U.S. NUCLEAR REGULATORY COMMISSION
STANDARD REVIEW PLAN
OFFICE OF NUCLEAR REACTOR REGULATION

3.6.2 DETERMINATION OF RUPTURE LOCATIONS AND DYNAMIC EFFECTS
ASSOCIATED WITH THE POSTULATED RUPTURE OF PIPING

DRAFT Rev. 2 - April 1996

Figure 3.6.2-1 Rated energy dissipating capacity³¹

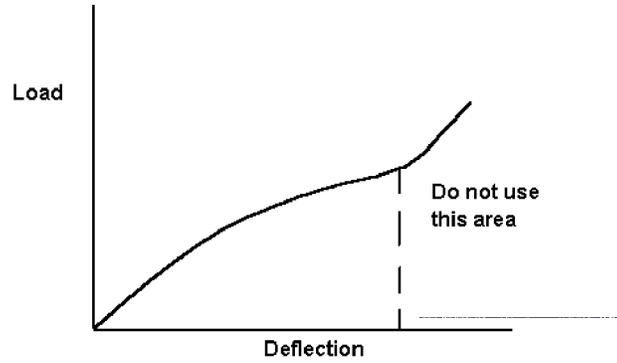
29.	SRP-UDP format item	Changed "BTP MEB 3-1" to "BTP EMEB 3-1."
30.	Editorial	Modified to improve clarity.
31.	Editorial	Placed border around figure and deleted cross-hatching under the curve in the figure. The intent of the cross-hatching was misleading.

Figure 3.6.2-2 Limitations on pure tension members³²

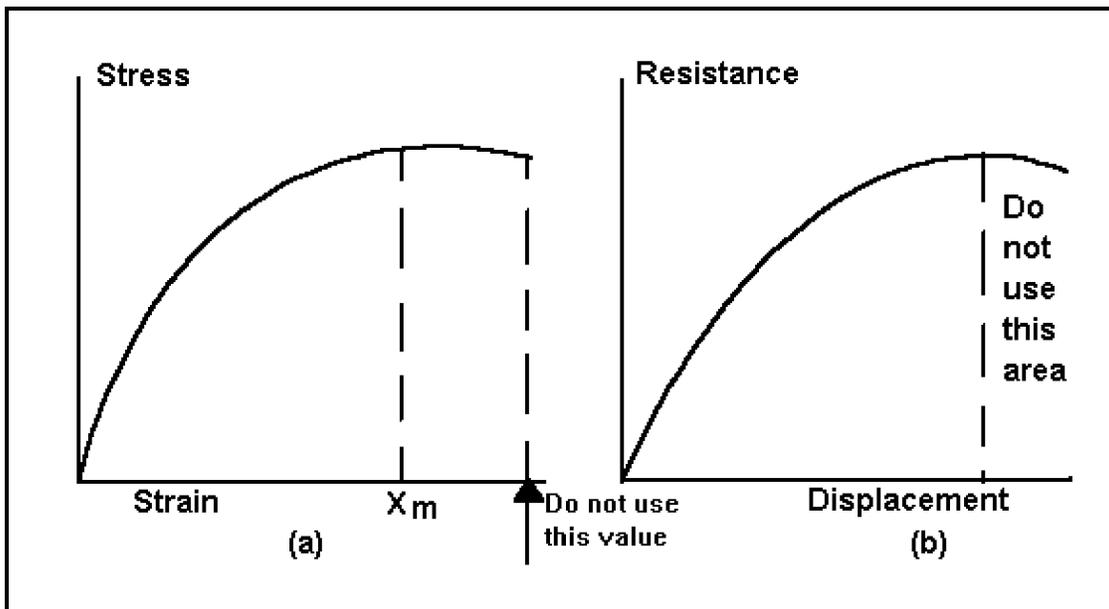
Item	Source	Description
32.	Editorial	Placed border around figure and deleted cross-hatching under the curve (b) in the figure. The intent of the cross-hatching was misleading.
